VEHICLE RECALL

**G-05507
August 2005**

SUBJECT: SAFETY RECALL (U.S., EXPORT)

**Child Seat Latch Attachment on CE, FE, and RE School
Bus models with Child Restraint Anchorage Systems
Option (Property Codes 0048SYH, SYJ, TAN, TGY, TGZ,
TJV, TMU, TMV, TMW, TMX, TNB, TPY, TXW) built
between 05-12-2003 and 03-02-2005**

Figure 1. Latch anchor brackets cut-off and belts installed

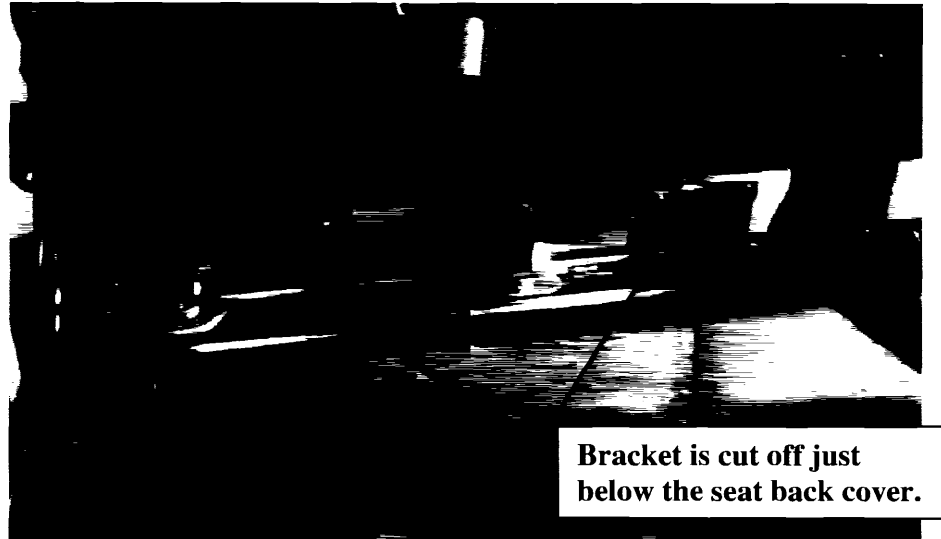
The diameter of the latch attachment bars may be so large as to make it difficult to use with future car seat attachments. Not attaching the child seat properly may result in personal injury or death.

In addition, some of the latch attachments may be located too far forward of the seat back. This placement of the brackets may result in personal injury to a passenger not seated in a child seat.

Remove latch attachments from seats and replace with a special belt system. This procedure does not require the removal of the seat assembly. Refer to Figure 1.

2. Cut the brackets off just below the seat back cover. Refer to Figure 1 below.
 - The bracket makes a bend in this area and has a minimum amount of material to cut through. It can be cut off closer to the seat frame if desired.

- There are two (2) brackets on 26" and 30" seats.
 - There are four (4) brackets on 39" seats.
3. Grind all cut edges smooth.
4. Paint.

- 1. On seats without existing lap belts** (Texas, North Carolina and Laidlaw only):
 - a. After removal of the latch system, add one set of belts and hardware provided in **Kit # 8900150R91** (at each position that the latch system was removed) using the holes provided in the bar that are approximately eight inches apart.

- b. You may need to place a large diameter flat washer between the belt mounting bracket and the plate in the seat to get a flat mounting.
 - c. Torque the fasteners to **21-27 LbF-Ft (28.5–36.6 Nm)**.
